SUBJECT:
RESPONSE TO NRC LTR DTD 02/23/78...FORWARDING ADDL INFO OF REPT NEDM-20988, "CAORSO RELIEF VALVE LOAD TESTS - TEXT PLANT" WHICH WAS SUBMITTED BY GE ON BEHALF OF THE MARK II OWNERS GROUP.

SUBJECT: MARK II CONTAINMENT REQUEST FOR ADDITIONAL INFORMATION

RESPONSE TO NRC COMMENTS OF JULY 7, 1977 AND FEBRUARY 23, 1978
ON CAORSO TEST PLAN

FIG. 5-5C PRESSURE SENSORS ON CONCRETE COLUMN

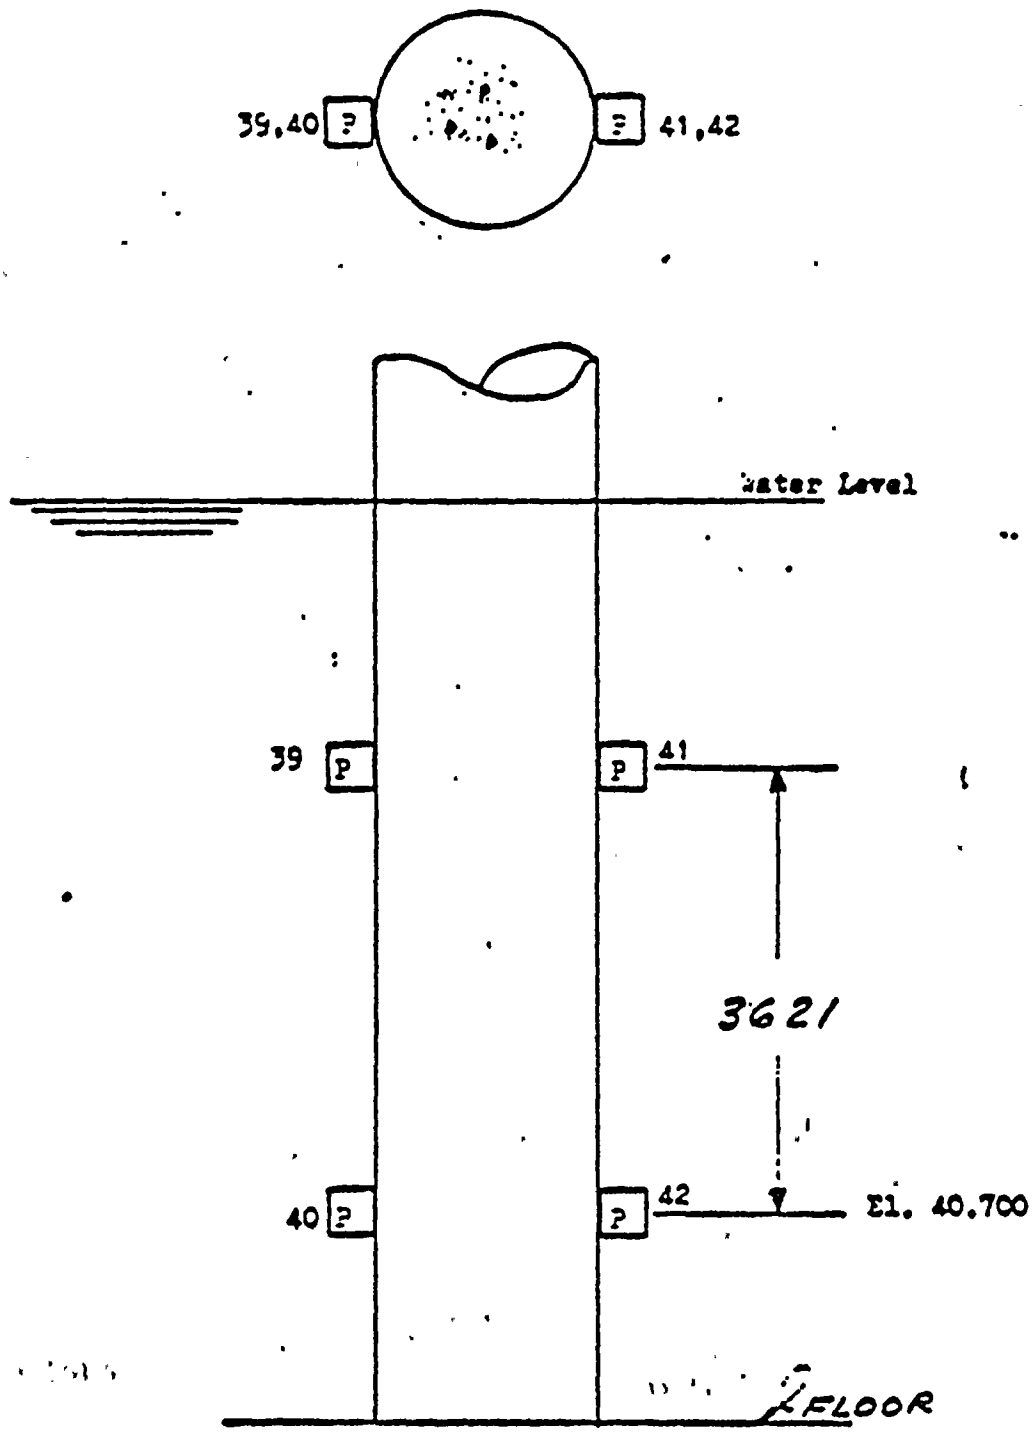
Submerged structure loads have been identified as a primary design load for the Mark II containment. We believe that the analytical program indicated in the Mark II Owners Group meeting which was held on February 16 and 17, 1977, is insufficient to support the design loads for submerged structure without experimental data. Therefore, we recommend that additional pressure sensors should be installed on support columns and downcomers to measure the drag load during SRV operation.

Measurements on two downcomers and a support column adjacent to Quencher A will provide the needed loads information. The instrumentation used, which is shown in attachments 6, 7 and 8 consists of the following:

2. Pressure transducers on Support Column No. 7 and Vent No. 9.
